## 9A Fire Hazards Analysis

The information in this appendix of the reference ABWR DCD, including all subsections, tables, and figures, is incorporated by reference with the following departures and supplement to 9A.1 Introduction. Additionally, the Fire Hazards Analysis for the Turbine Building in Section 9A.4.3 is replaced in its entirety.

Figure 9A.5-2 Typical Electrical Equipment Connection Block Diagrams of Special Cases

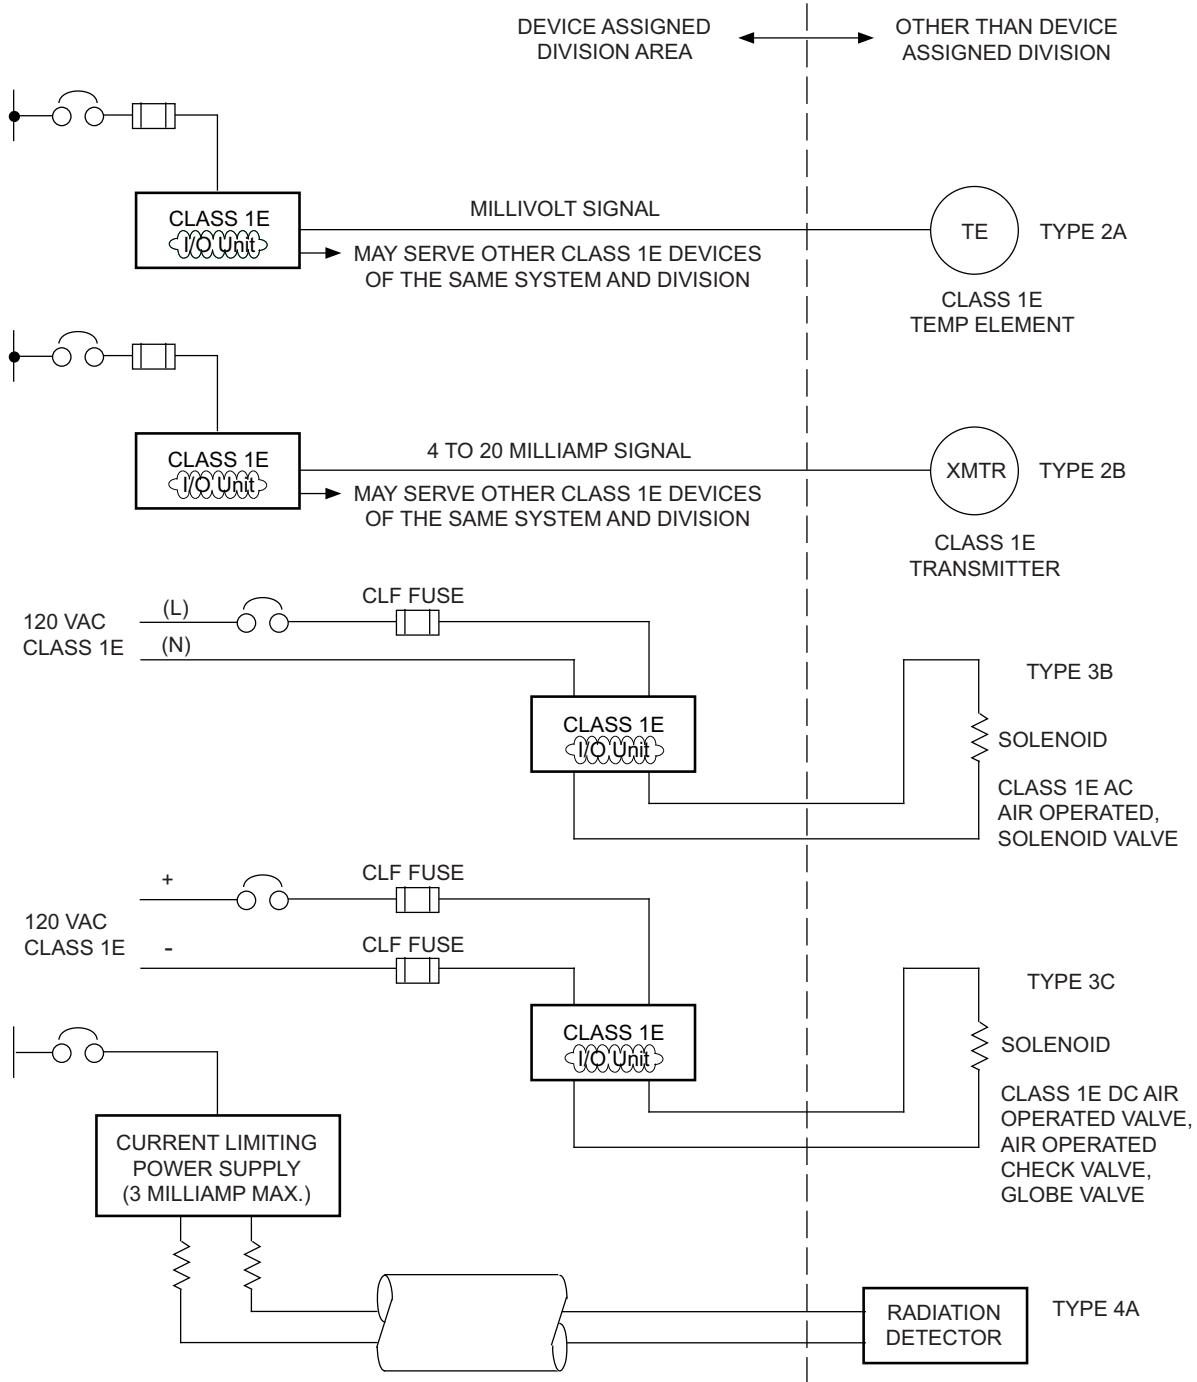
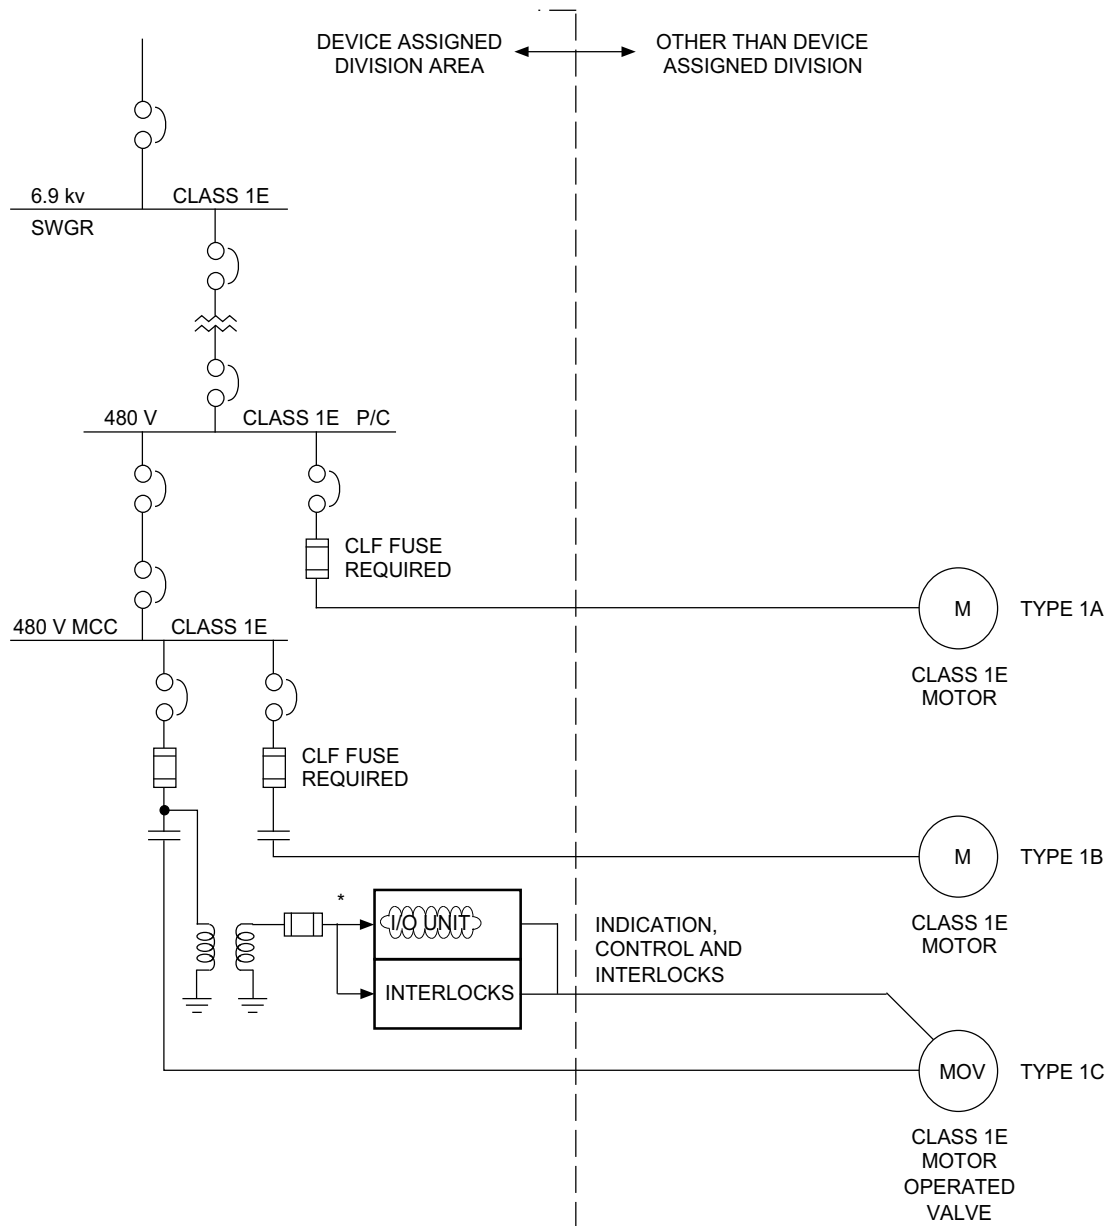
STD DEP T1 3.4-1 ([Figure 9A.5-2](#))

The power for operating DC solenoid valves is supplied from the DC distribution system to the ~~demultiplexer~~ data link/O unit for the valve. Both the supply and return for the DC are fused ~~at the multiplexer~~ so that faults are isolated and do not propagate back up into the portions of the DC system common with other systems. |

\* IT IS A REQUIREMENT THAT THE INDICATION, CONTROL AND INTERLOCK POWER FOR THIS DIVISIONAL CROSS-OVER TYPE BE FROM A CONTROL POWER TRANSFORMER IN THE CUBICLE SUPPLYING POWER TO THE MOV.
